TO: Troy Kelts, Galloway & Company
FROM: Stacey Nerger, Senior Planner
DATE: November 15, 2023
SUBJECT: The Exchange Lot 1 – Site Plan
Review Comments 01

Staff Comments 01
SP23-080; The Exchange Lot 1
Site Plan
November 15, 2023

PARKER EXCHANGE BUILDING SITE DEVELOPMENT PLAN

COVER SHEET

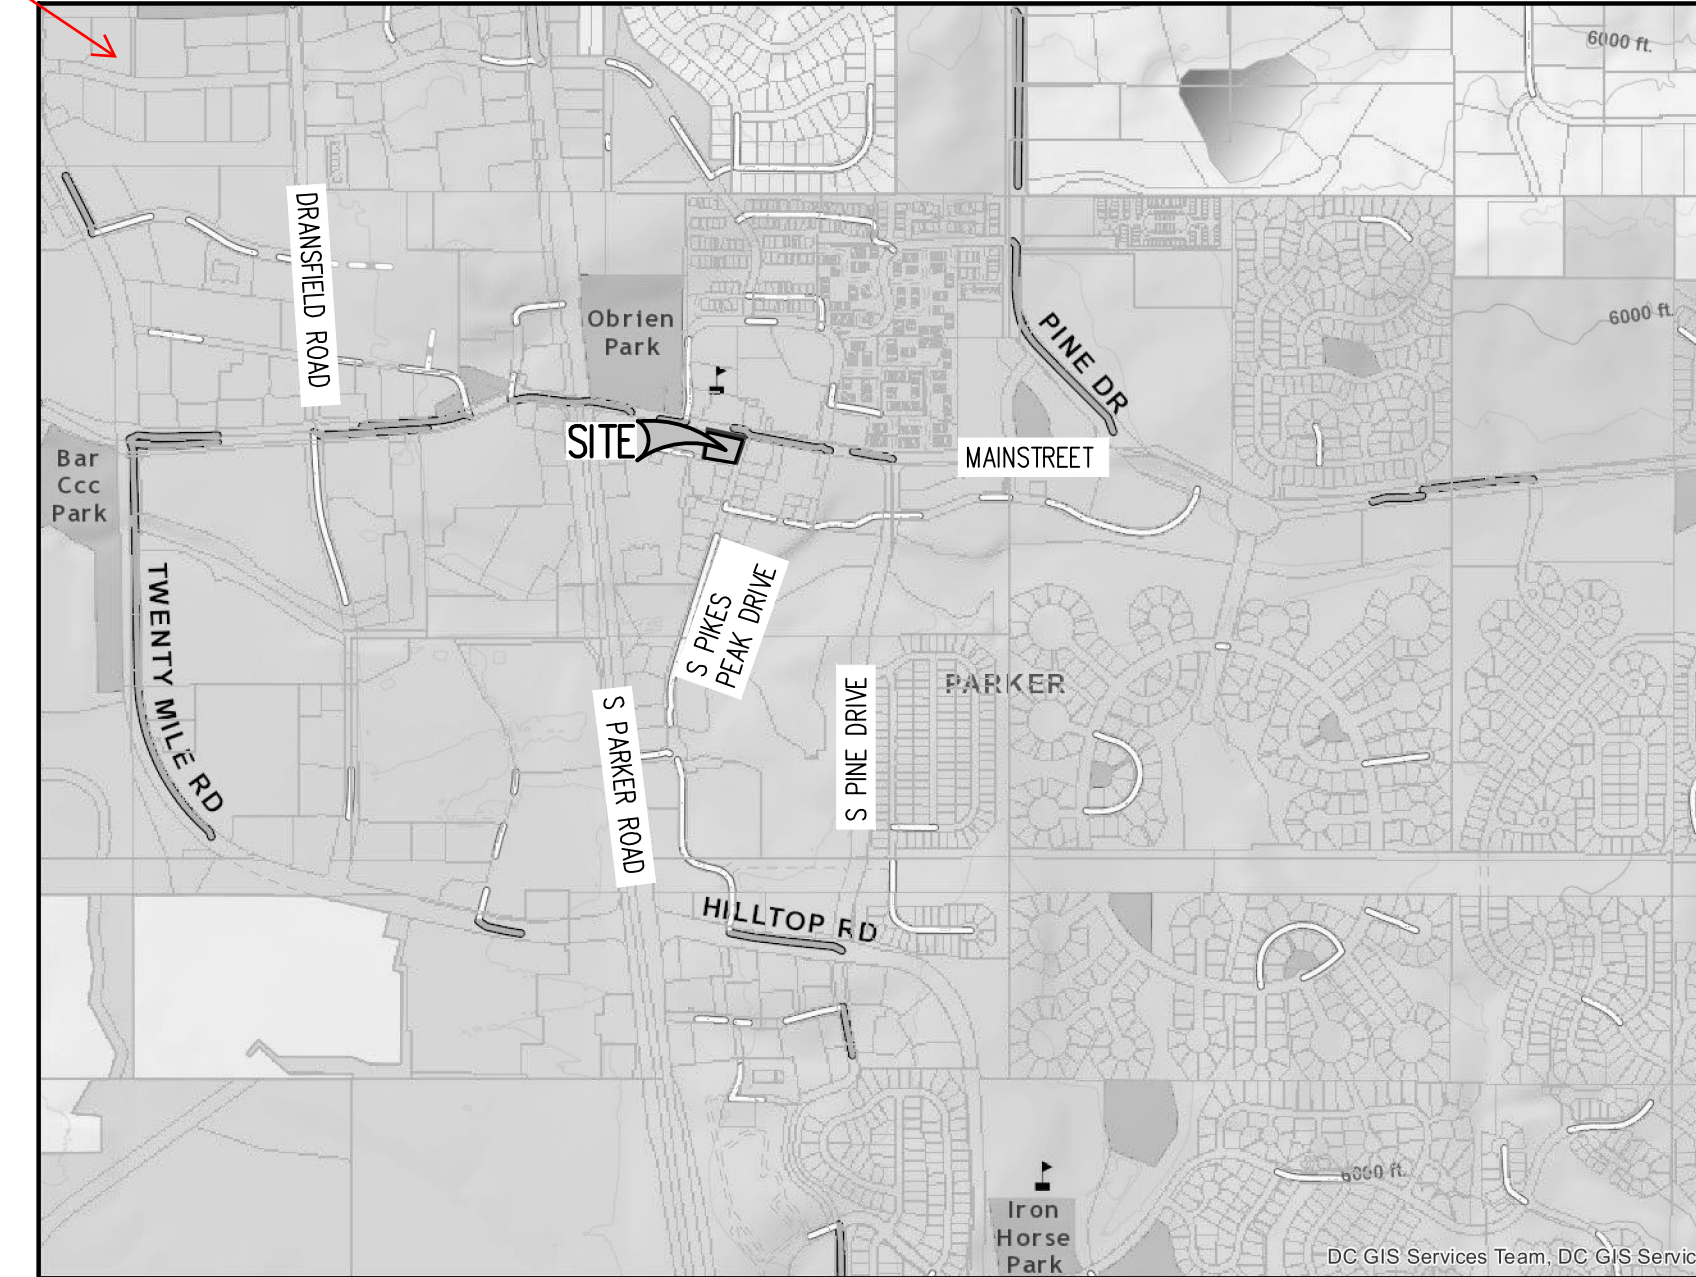
The main title of the document should be the legal description of the property.

Zoom this map in so the property is more visible.

Please include a Site Development Table that outlines the proposed development. Since this includes an existing building, please include existing and proposed information (Building sq ft, parking, landscaping, setbacks, height, etc.). Please also include the proposed use of the addition. This way we can verify that the proposed use is permitted in zoning.

SITE PLAN
2
2 OF 15

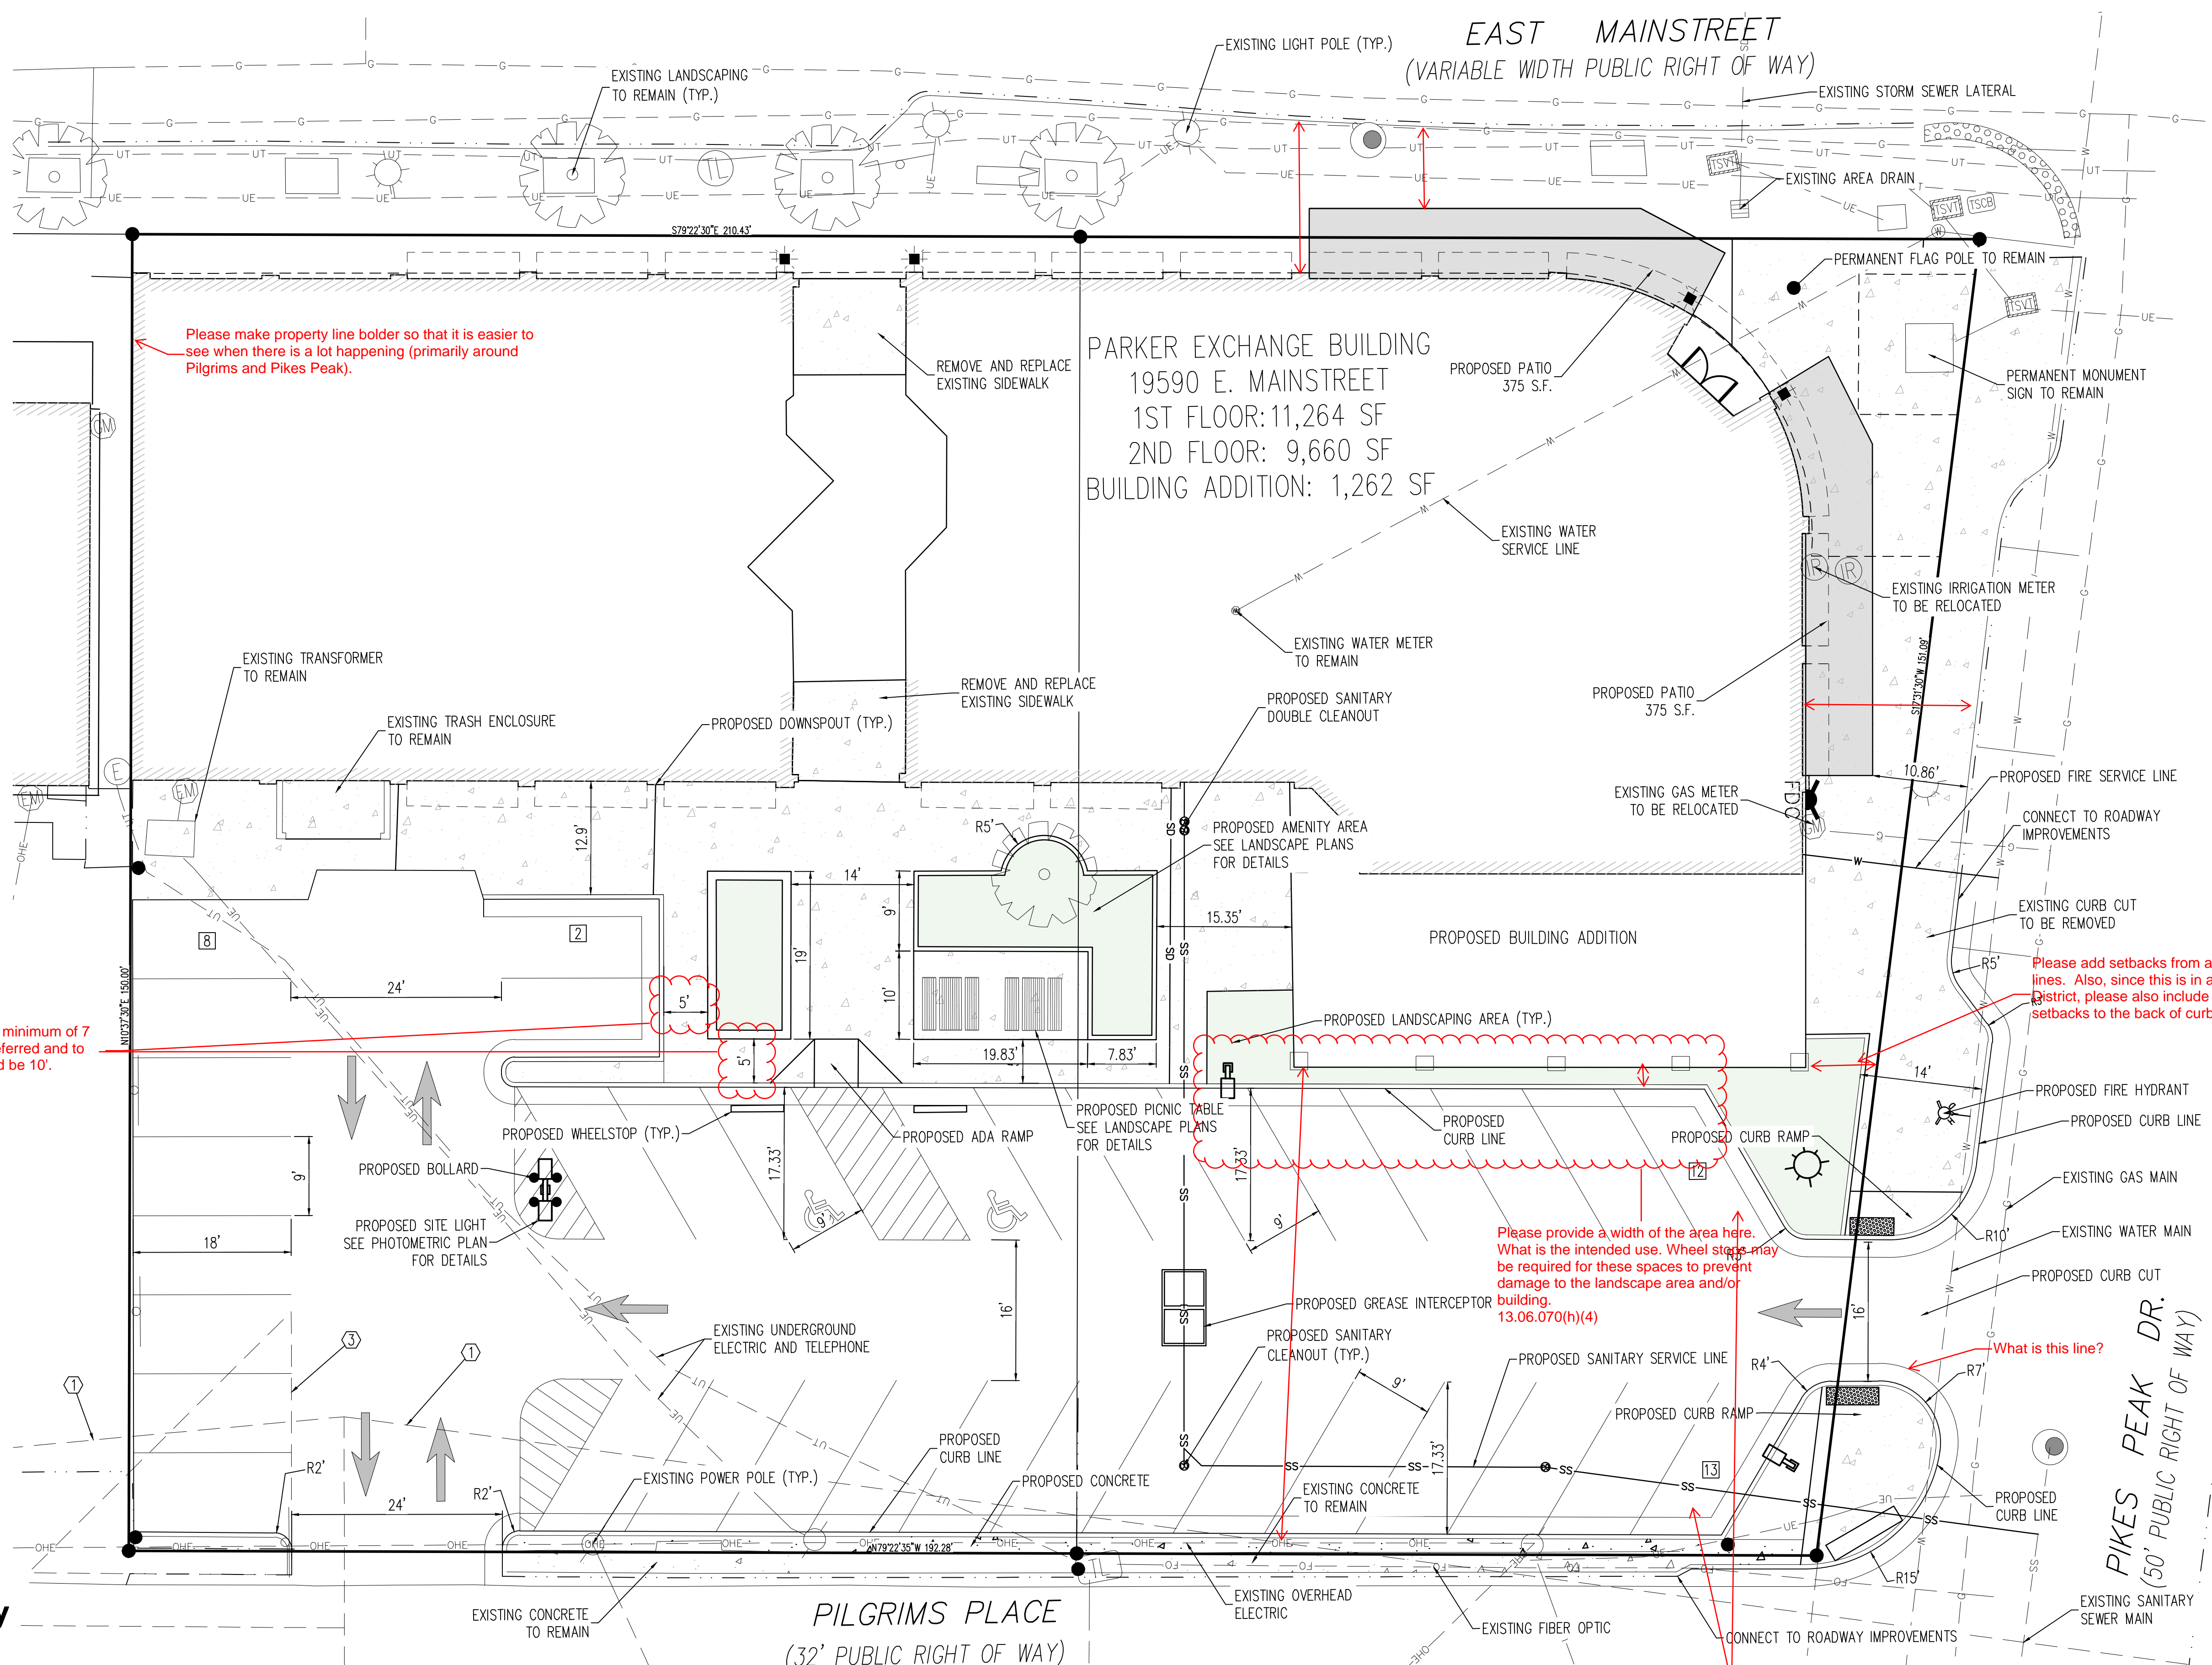
Please provide the distances as required by code. See Planning memo for more information.

Parking spaces adjacent to landscape islands are required to 10 feet in width or the landscape island shall include an 18 inch concrete curb to allow people to get out of their cars.

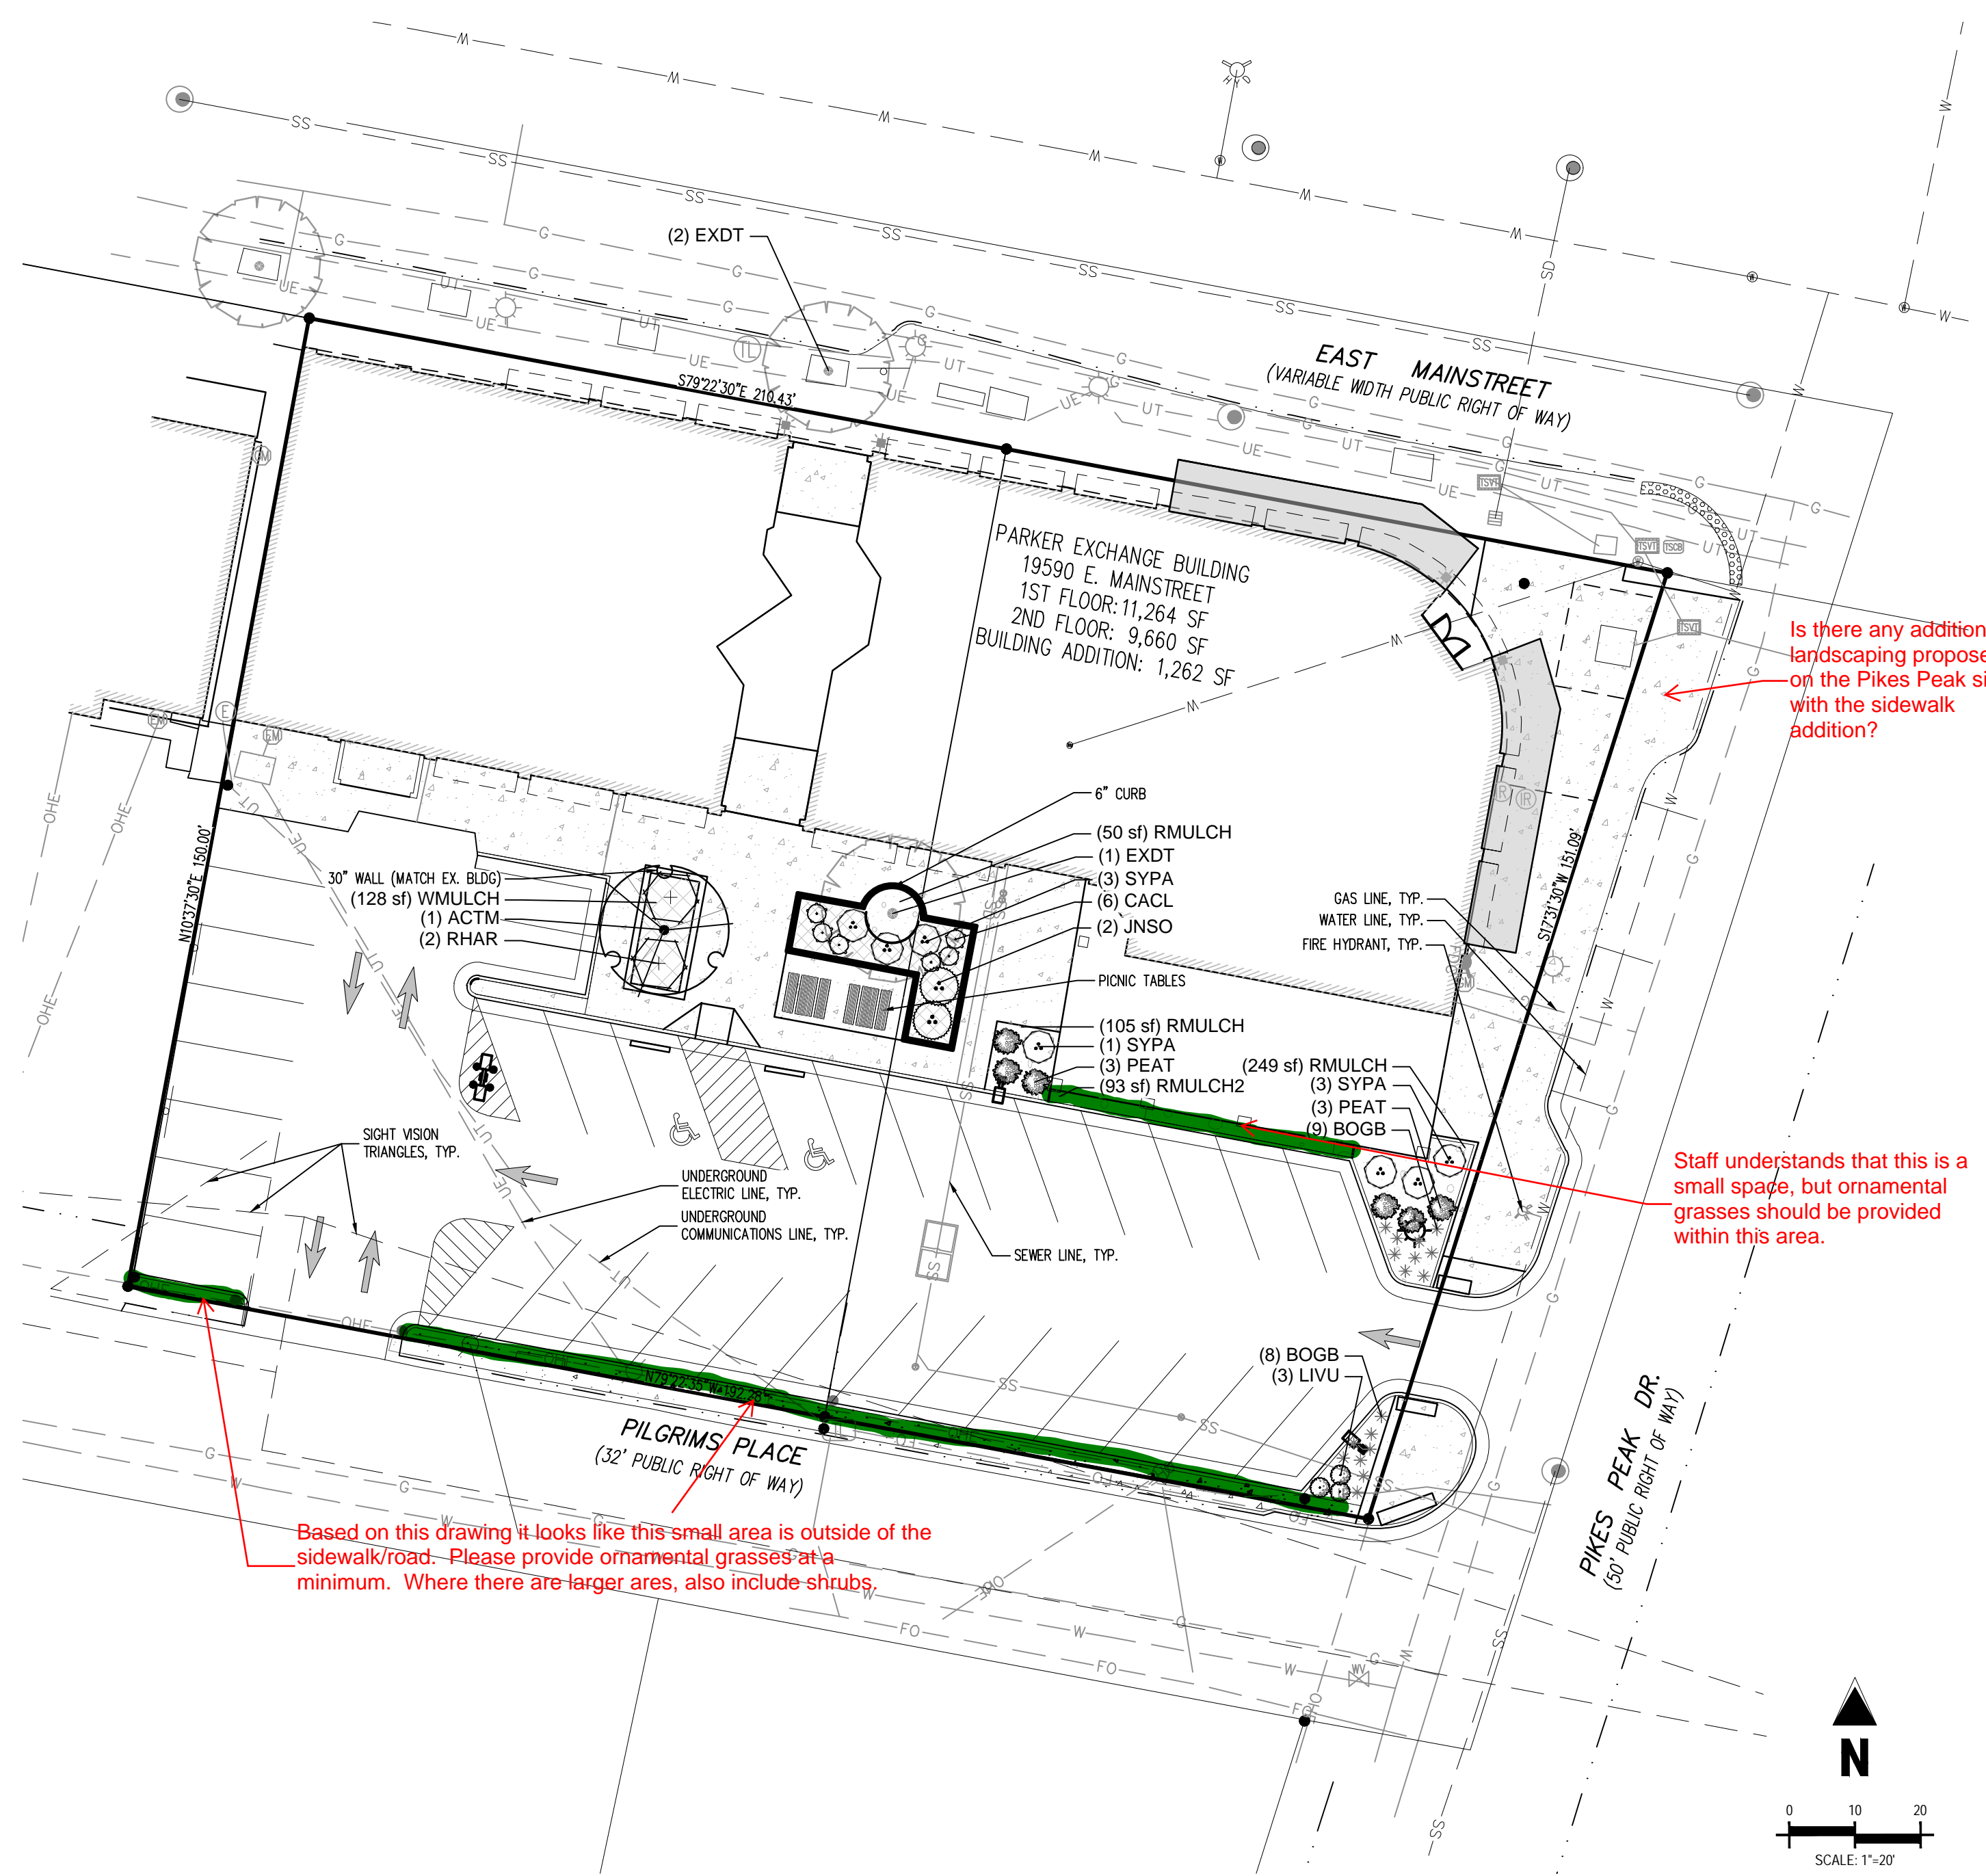
Please verify that the quantities listed in this table match the actual plans.

Based on this drawing it looks like this small area is outside of the sidewalk/road. Please provide ornamental grasses at a minimum. Where there are larger areas, also include shrubs.

Please submit a landscape table for reference. Since most of the site is existing, please provide an existing landscaping breakdown along with what is proposed. Below is an example of what this could look like:

Please include the sheet numbers on all pages.

TOWN OF PARKER SHRUB PLANTING STANDARD N.T.S.

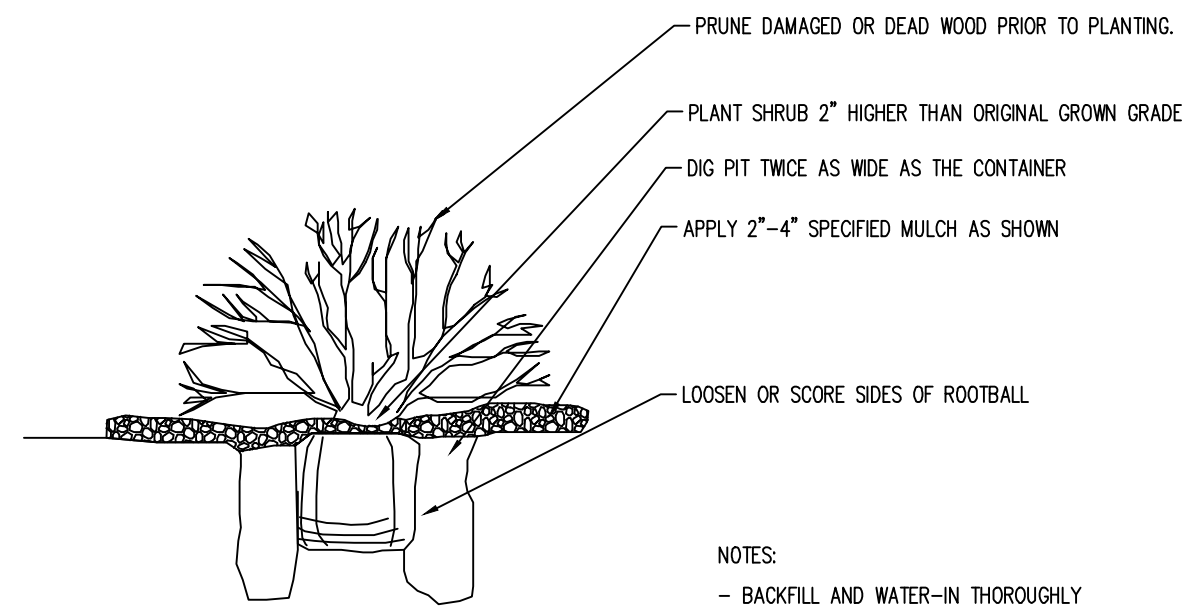
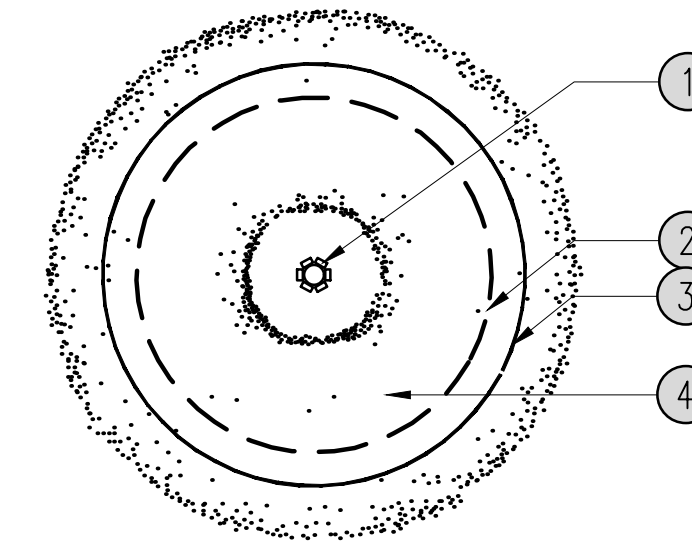
Please add a note that states 'All changes to the approved landscape plan must first be approved by The Town of Parker Planning Department.'

Please add a note that geotextile fabric is required for all shrub and ornamental grass beds.
